Florida Department of  
Environmental Protection  
Inspection Checklist

**Facility Name:** SOUTHEAST COUNTY SLF (PICNIC LF)

**On-Site Inspection Start Date:** 11/09/2011

Routine Operation Inspection for Landfill - Class I facility

SW system construction

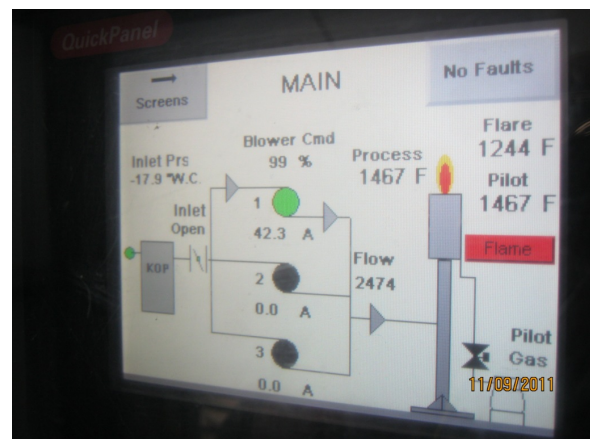
Item 2.29 - A sub-contractor was constructing the modified surface water management system (infiltration/dry basins to ponds) at the time of the inspection.
